Access Compliance Report

(Curb Ramps)

Intersection ID: 10906	Main Street: W_TRADE_ST	Cross Street: MONTGOMERY_ST	Location: N
ADA ID: 5418B0F6A538	Ramp Type: PerpDiag	Initial Pass/Fail: Fail	Overall Compliance: No
Severity Score: 21.25			
Codes/Mitigation Info/Possible Solution		Field Measurements/Component Compliance

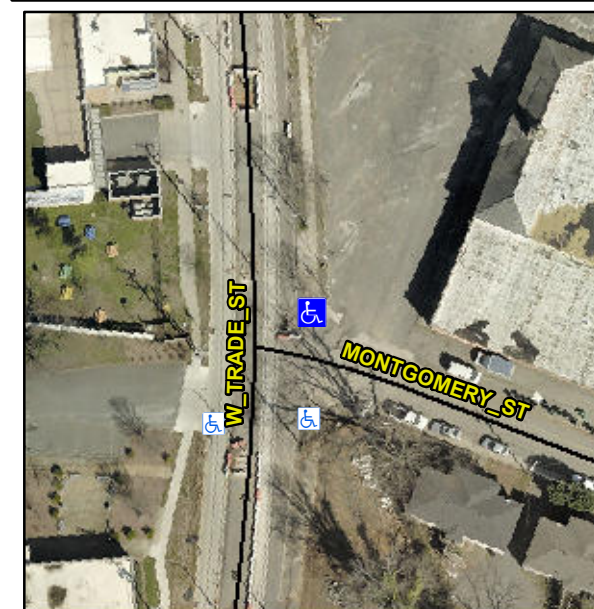
R304.5.1, R304.2.2

Compliance	Description	Data	Compliance	Description	Data
N/A	Ramp Length (in)	67.0	No	Ramp Slope (%)	9.7
No	Ramp Width (in)	45.0	Yes	Ramp XSlope (%)	0.6
N/A	Flare Type LT	N/A	N/A	Flare Type RT	N/A
N/A	Flare Slope LT (%)	N/A	N/A	Flare Slope RT (%)	N/A
N/A	Flare Traversable LT?	N/A	N/A	Flare Traversable RT?	N/A
N/A	Landing Length (in)	N/A	N/A	DWS Provided?	N/A
N/A	Landing Width (in)	N/A	N/A	DWS Contrast?	N/A
N/A	Landing Slope (%)	N/A	N/A	DWS Length (in)	N/A
N/A	Landing X Slope (%)	N/A	N/A	DWS Full Width?	N/A
N/A	Landing Curb? (Y/N)	N/A	N/A	DWS Offset (in)	N/A
N/A	Shared Landing?	N/A			
N/A	Gutter Ponding?	N/A	N/A	Gutter Slope (%)	N/A
N/A	Gutter Lip Ht (in)	0.5	N/A	Gutter X Slope (%)	N/A
N/A	Painted X Walk1?	No	N/A	Painted X Walk2?	No
	X Walk 1 Direction	To S		X Walk 2 Direction	To E
N/A	X Walk 1 Width (in)	N/A	N/A	X Walk 2 Width (in)	N/A
	X Walk 1 Slope (%)	2.1		X Walk 2 Slope (%)	3.7
	X Walk 1 X Slope (%)	2.0		X Walk 2 X Slope (%)	0.9

Remove & Replace Curb Ramp With Two New Directional Ramps or Equivalent.
